Interactive comment on “The influence of precipitation and temperature input schemes on hydrological simulations of a snow and glacier melt dominated basin in Northwest China” by X. Ji and Y. Luo

X. Ji and Y. Luo

Received and published: 15 April 2013

Fig. 1.

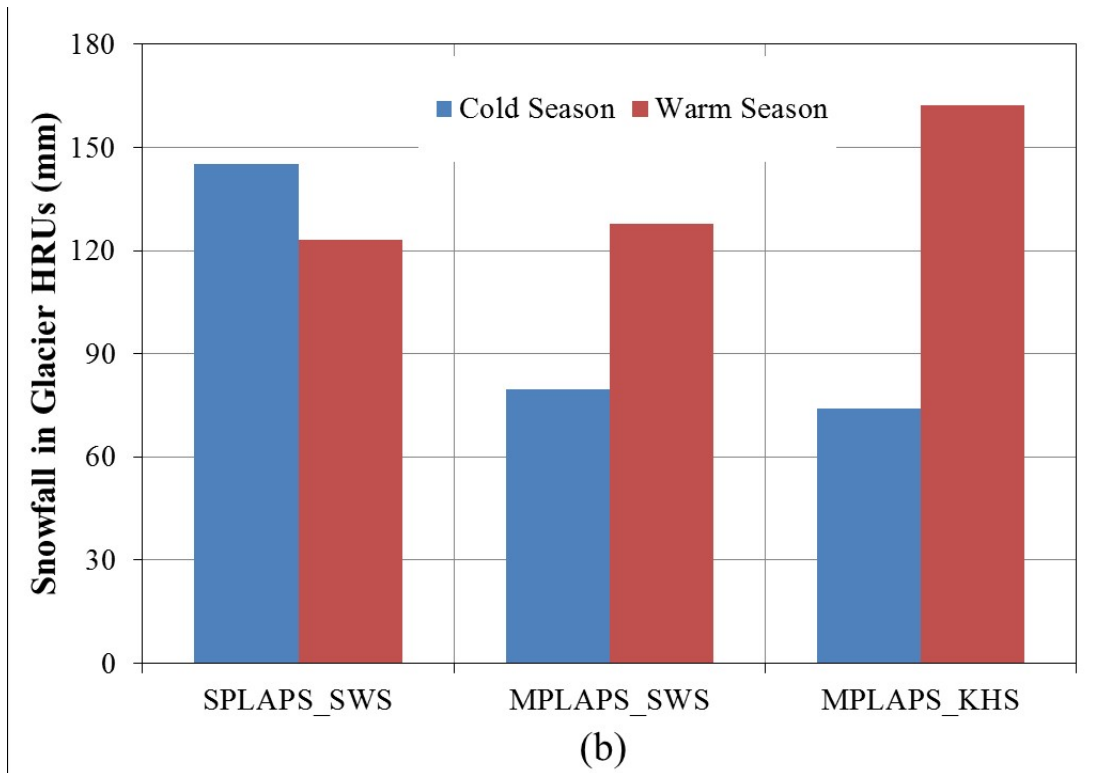
Comments:P849 Figure 7 Need to give the glacier coverage of two HRU

Reply: The HRUs represent different combinations of soil and land-use types. The HRU is not geo-referenced within a subbasin of SWAT model. The selected two glaciers are located within the subbasin 11 and subbasin 21, respectively, Figure 1. GHRU011076 is the 76th HRU and located within the subbasin11 with an area 15.79km² and accounting for 5% of the subbasin area. GHRU021122 is the 122th HRU located within to the subbasin 21 with an area 25.28km² which accounts for 24% of the subbasin.
